ADDENDUM NO. 11

PROJECT TITLE - PA State Police Greensburg - DNA Laboratory Facility New Building

ADDENDUM 11

MEP REVISION #1 - 11/15/2022

DRAWN BY E HOOVER	DATE 05/24/2022	DRAWING NO. E402P (VOLUME 1 OF 1)
CHECKED BY S MULHOLLEN	SCALE 1/4" = 1'-0"

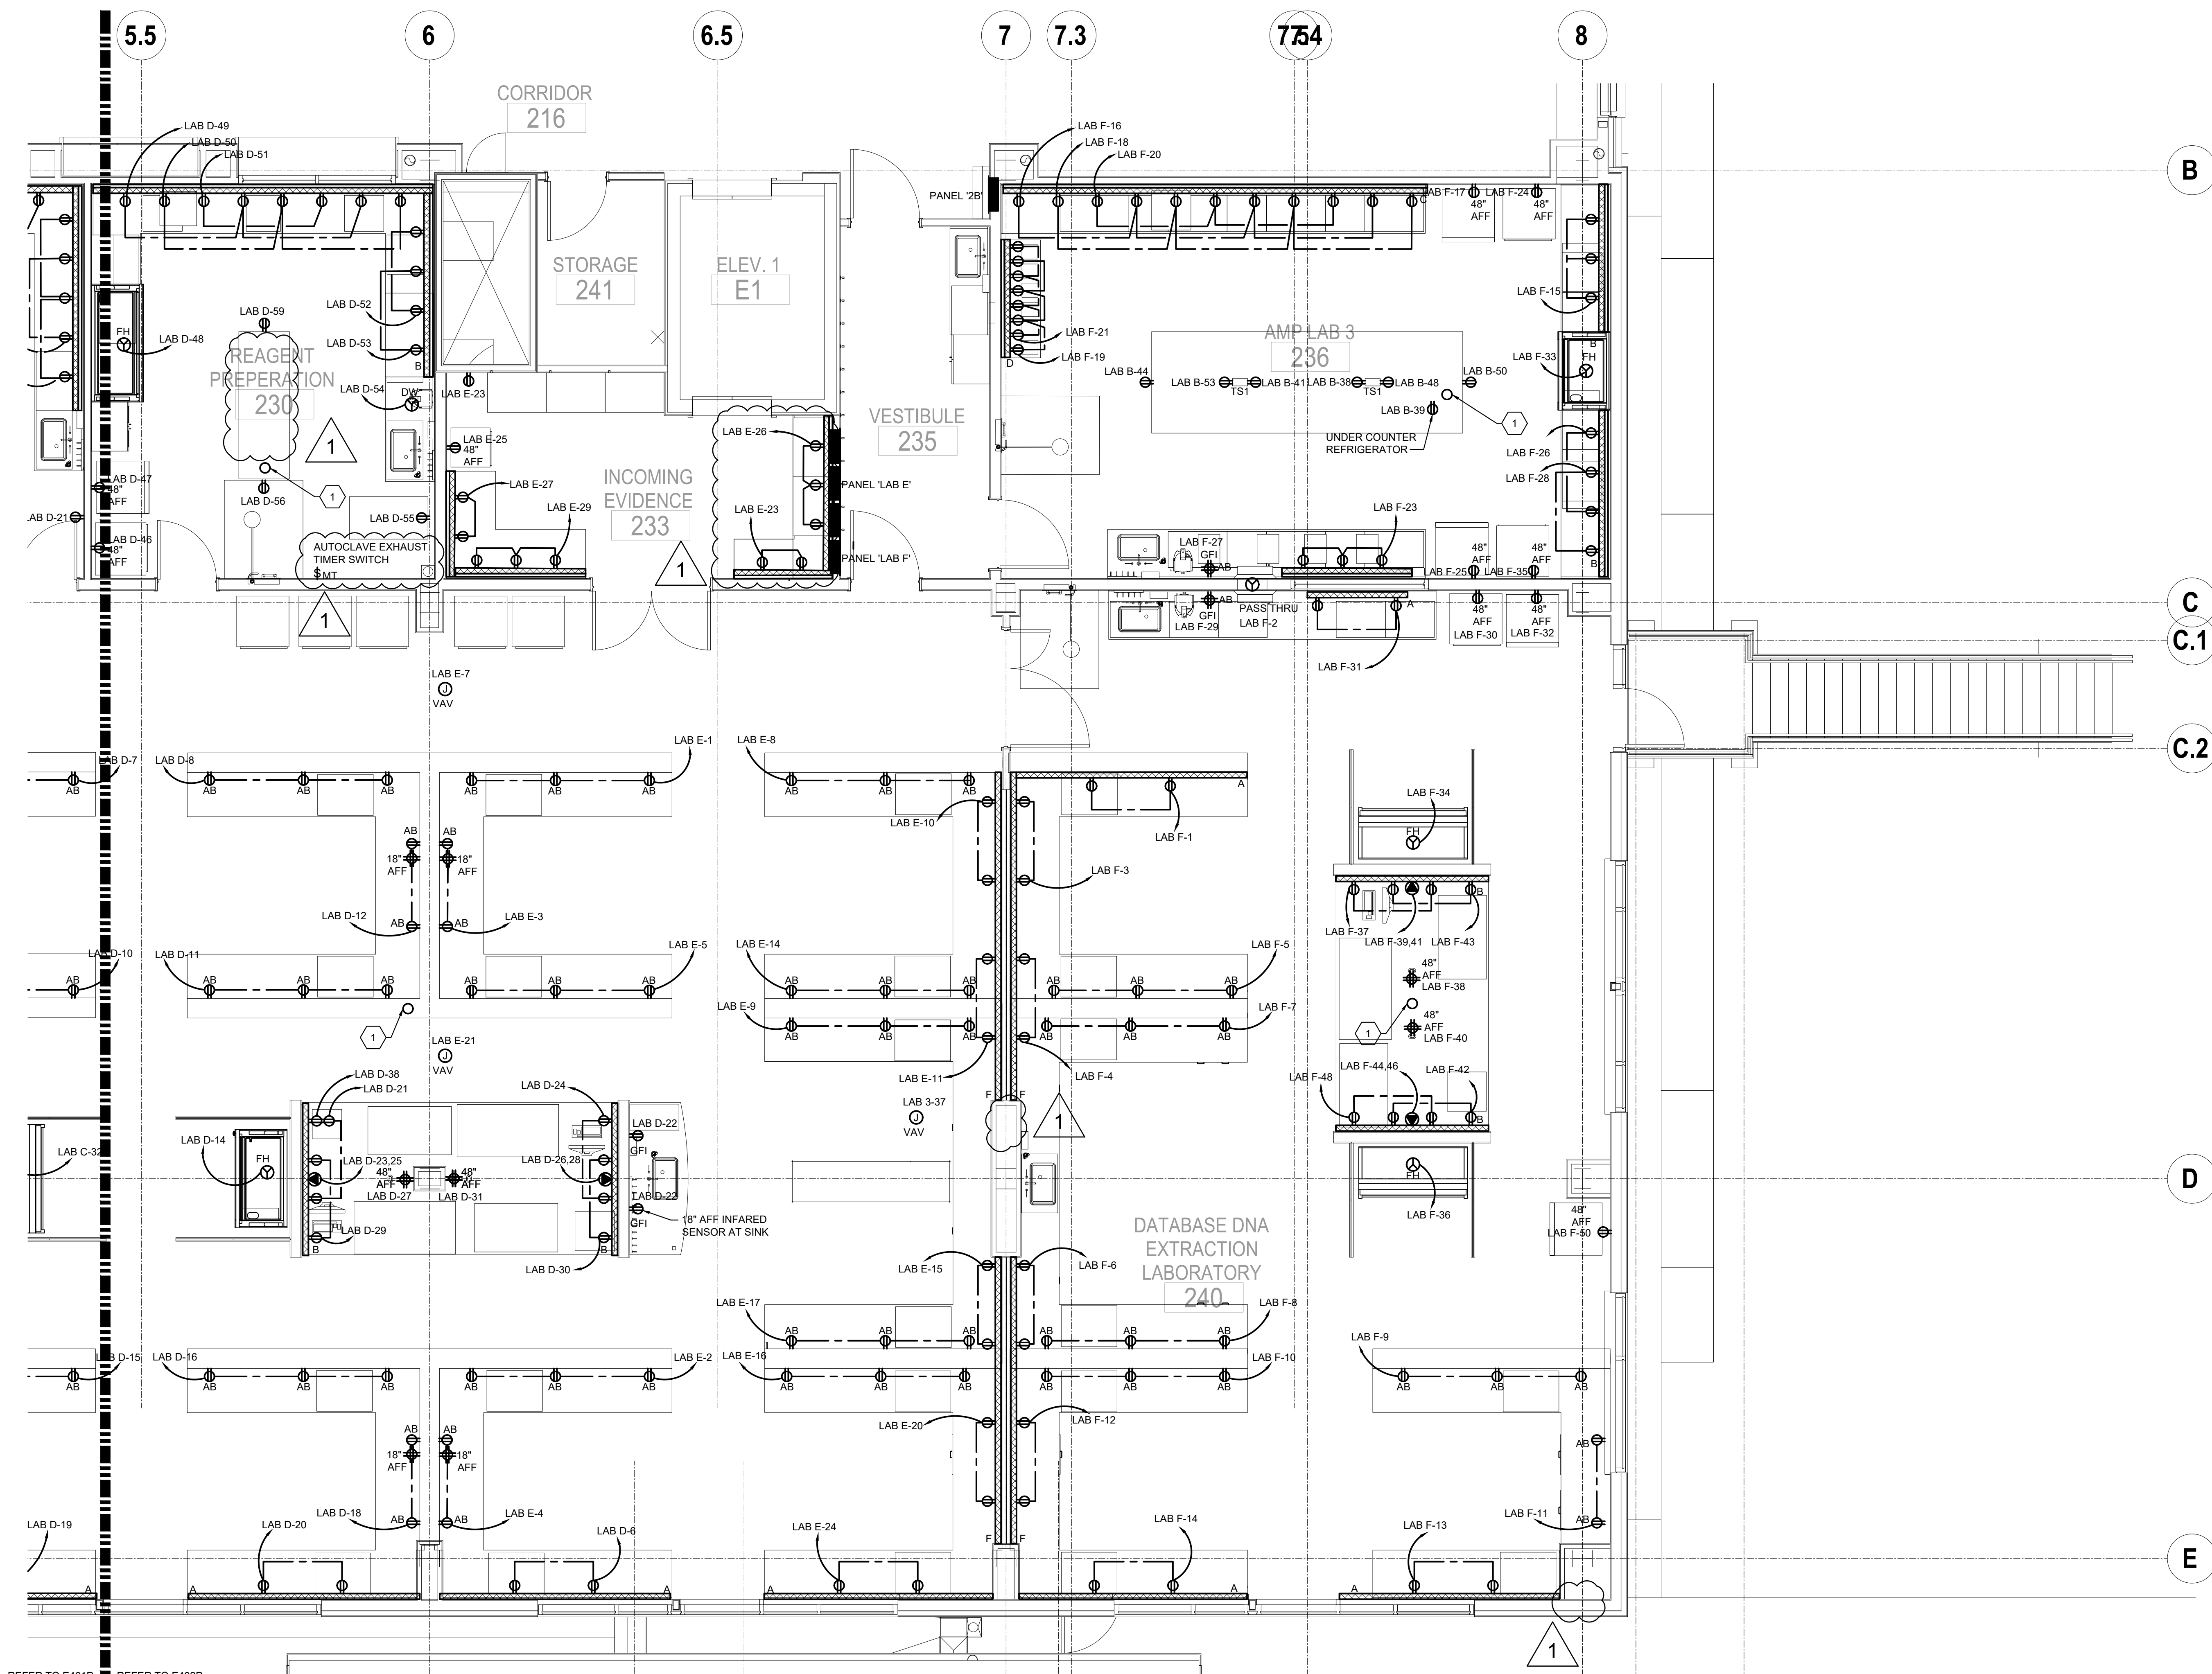
E402P - Added raceway to room 233. Adjusted raceway lengths in open lab area.

E402P - Added timer switch in room 230.

DRAWN BY E HOOVER	DATE 05/24/2022	DRAWING NO. E402S (VOLUME 1 OF 1)
CHECKED BY S MULHOLLEN	SCALE 1/4" = 1'-0"

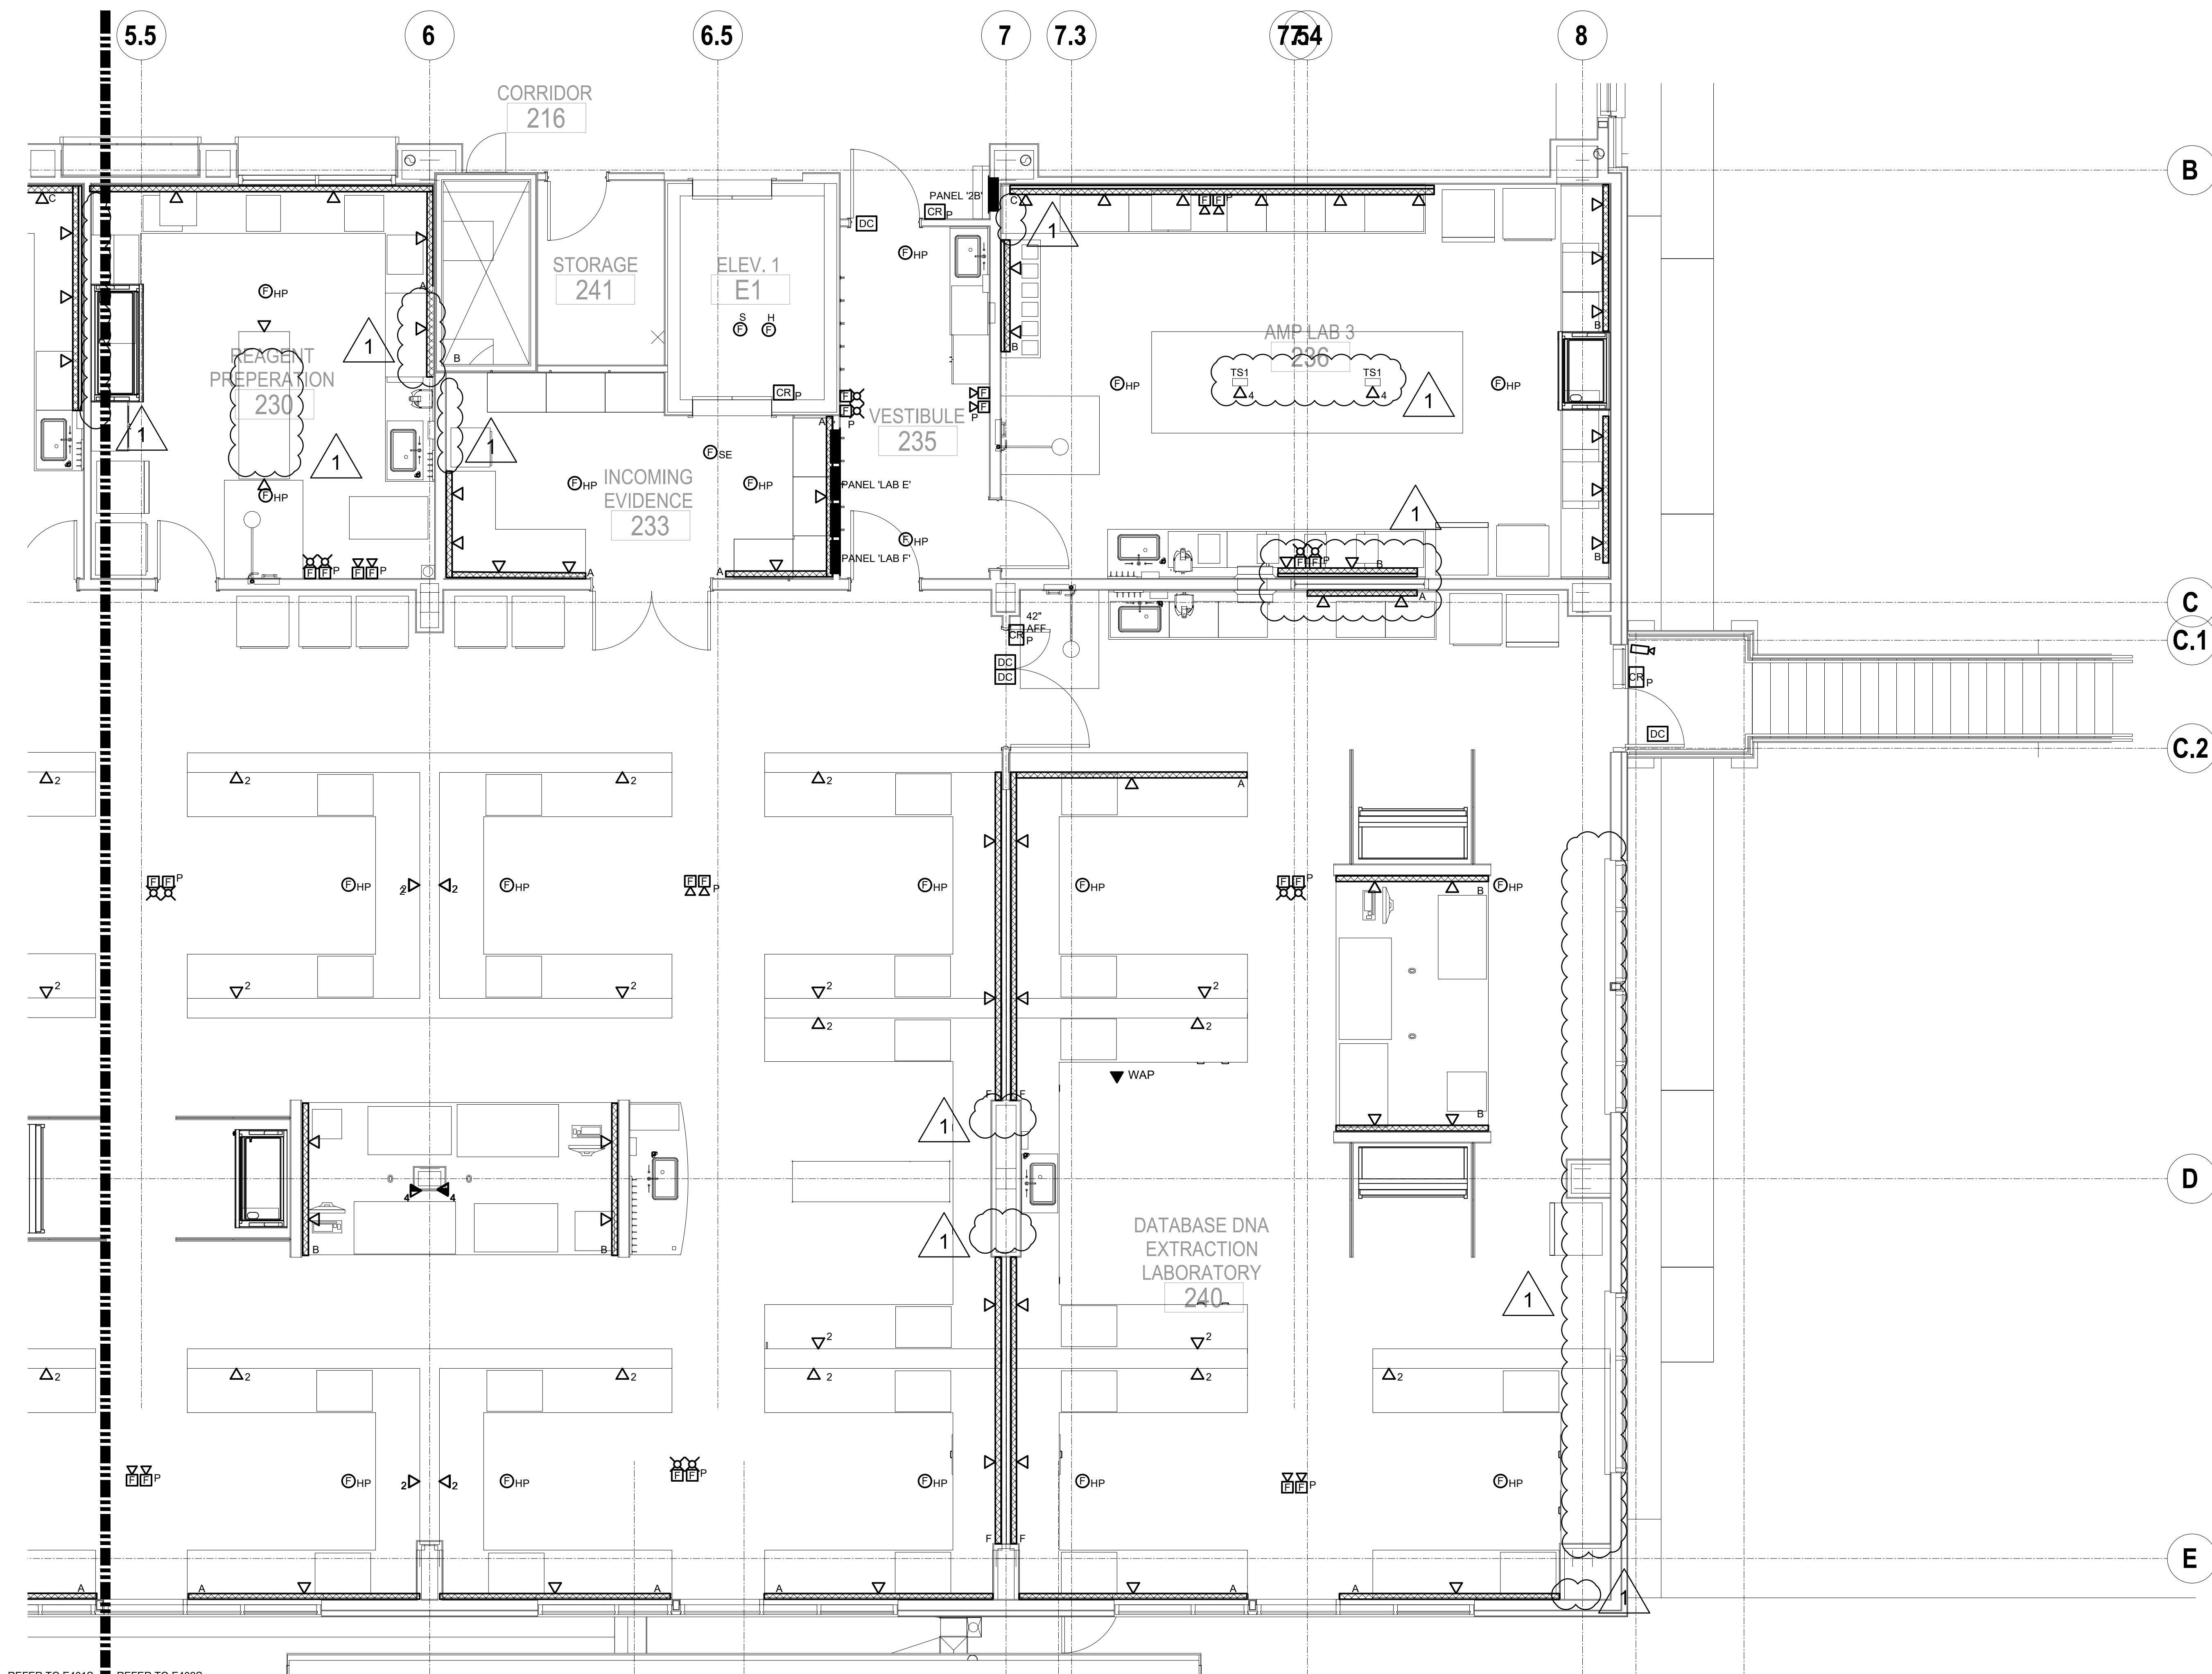
E402S - Added identification tag for Tombstone pedestal boxes.
